M-43

BUS

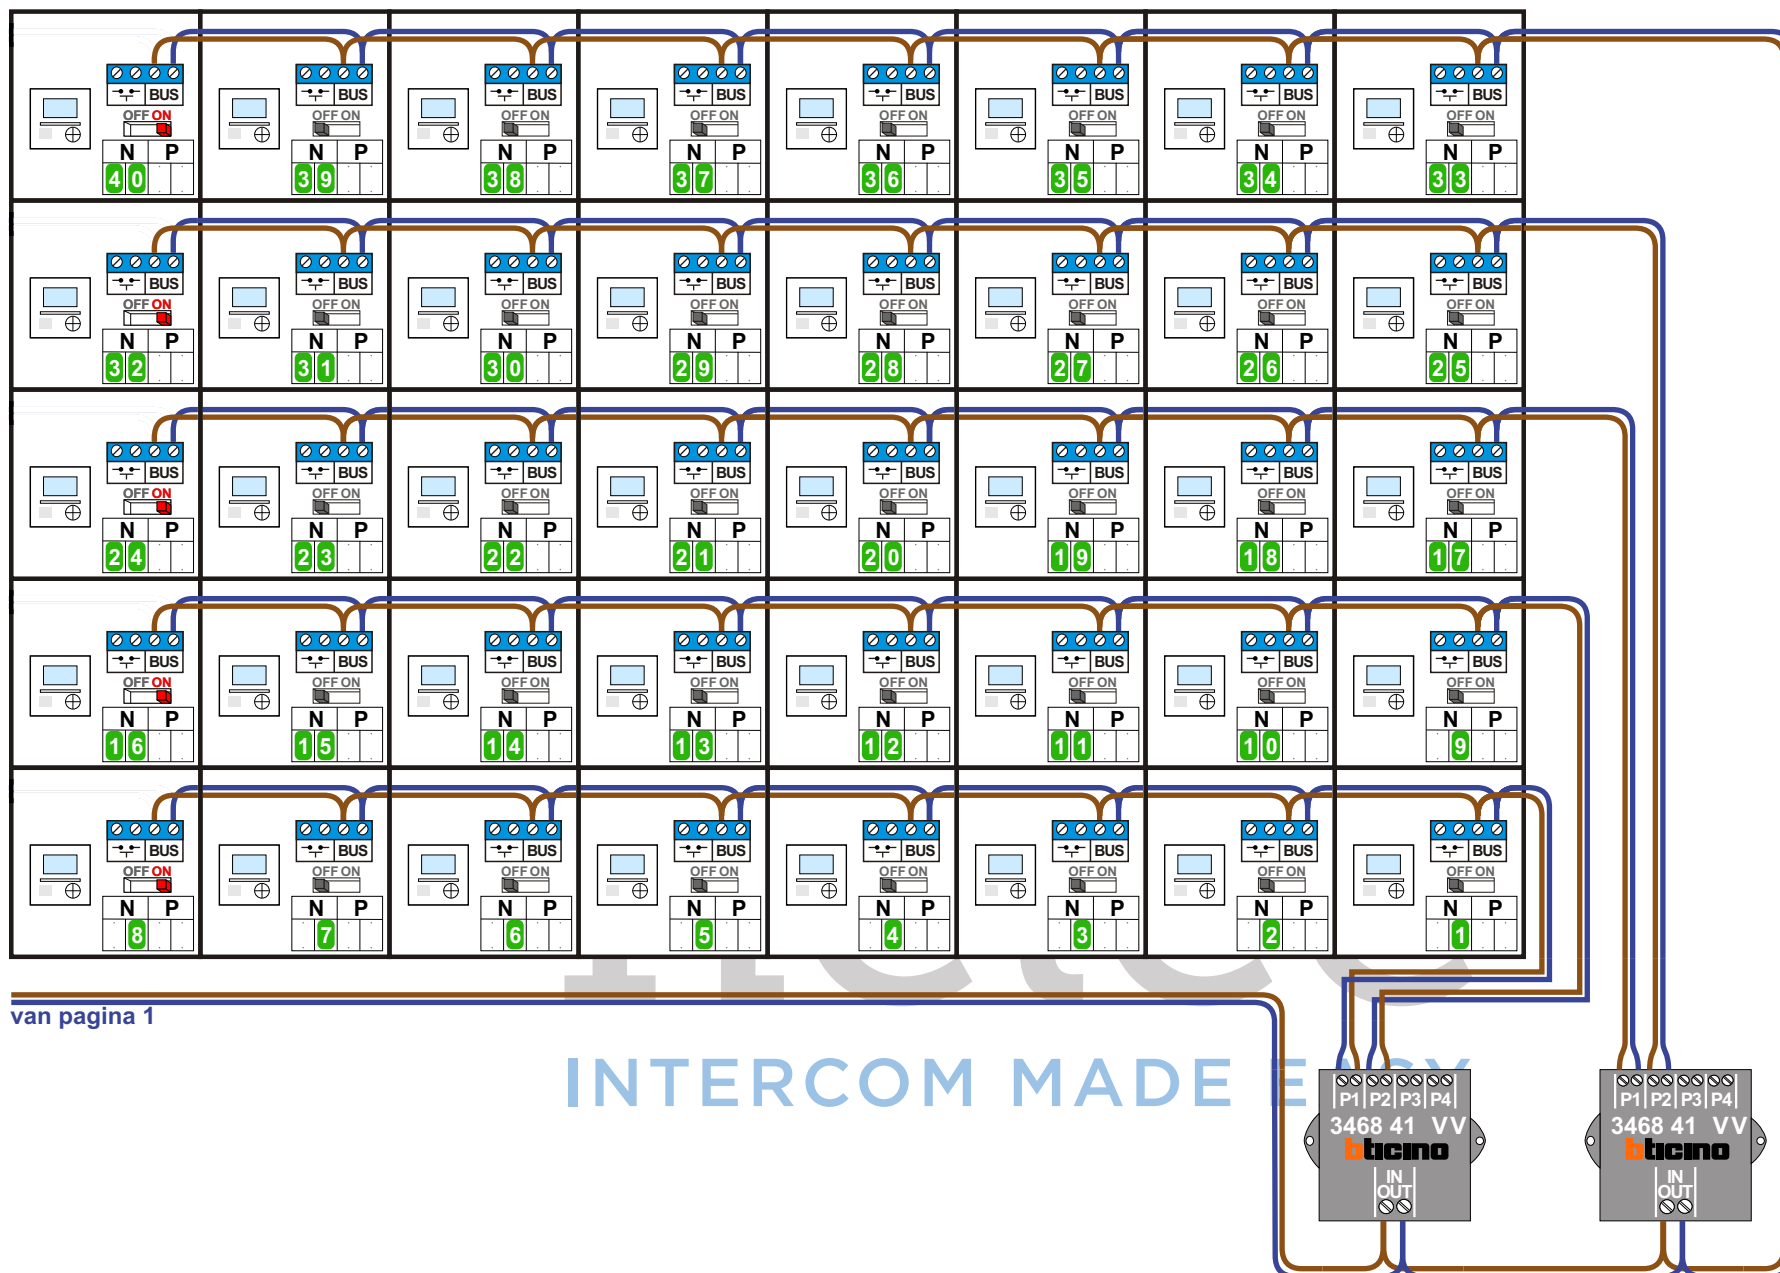
De aders moeten
echt OP de connector
doorgelust worden!
